SERVICE BULLETIN

Subject: New Kibes RT Updated Software and Implementing Freewheeling Diodes for Mux-5B Bulletin

Bulletin No: TS45-FM-2401

Vehicle Model: TS45

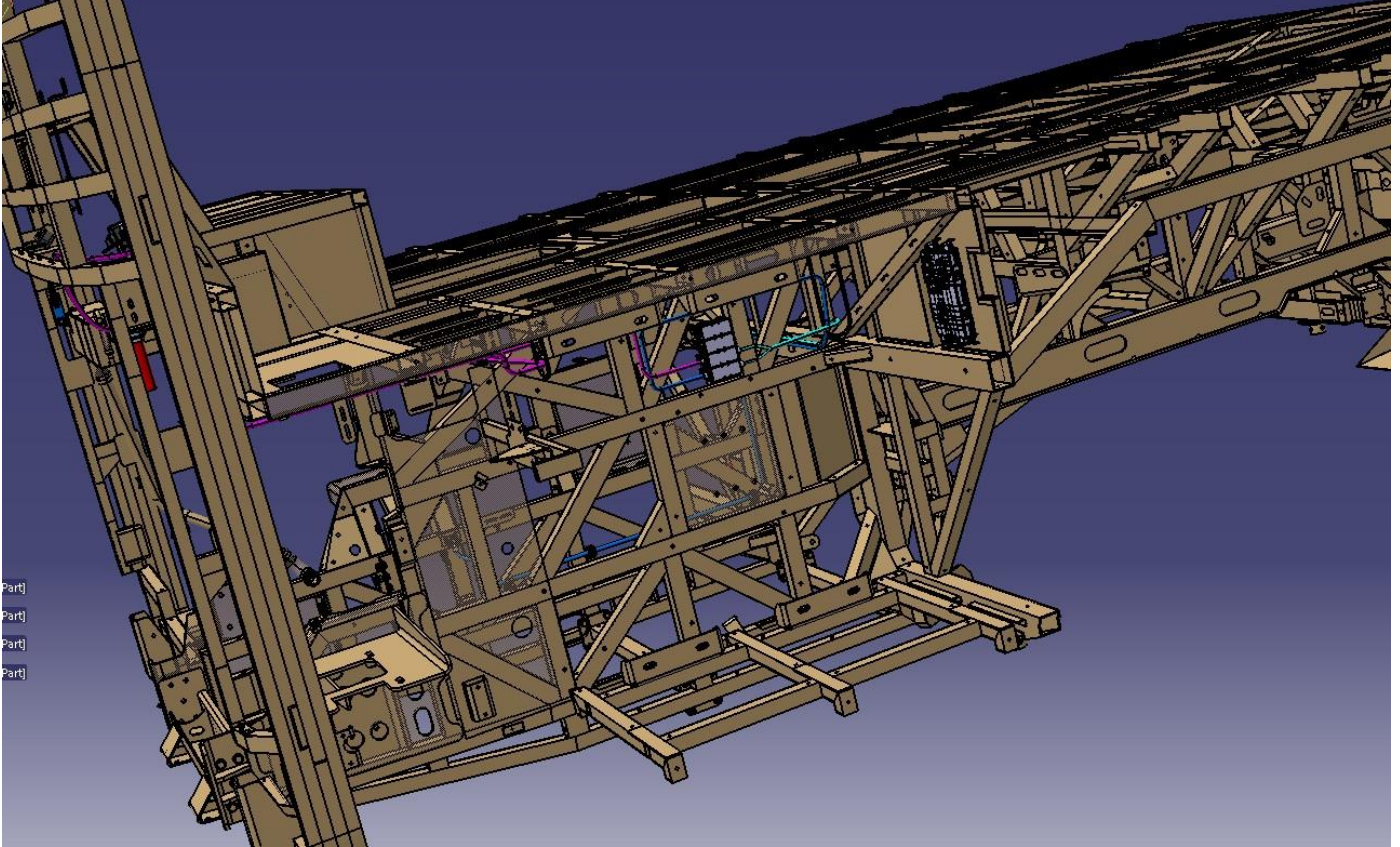
- 1-Open the relay panel lid.
- 2-Locate the MUX5-B 1.1 Which is numbered as 06A033.

- 3-Locate the connector numbered P06A033-B
- 4- To its 15th and 16th pins do the operation explained below.
 - 1-Strip the cable from its 5 cm away from the connector side.
 - 2- Connect the diode's cathode pin to striped part of the cable.
 - 3- Connect the diode's anode pin to nearest ground cable.

5- Open the lid of lift compartment.

6- Locate the MUX5-B 2.1 Which is numbered as 06A037.

7- Locate the connector numbered as P06A037-C

8- To its 21st pin do the operation explained below.

- 1- Strip the cable from its 5 cm away from the connector side.
- 2- Connect the diode's cathode pin to striped part of the cable.
- 3- Connect the diode's anode pin to nearest ground cable.
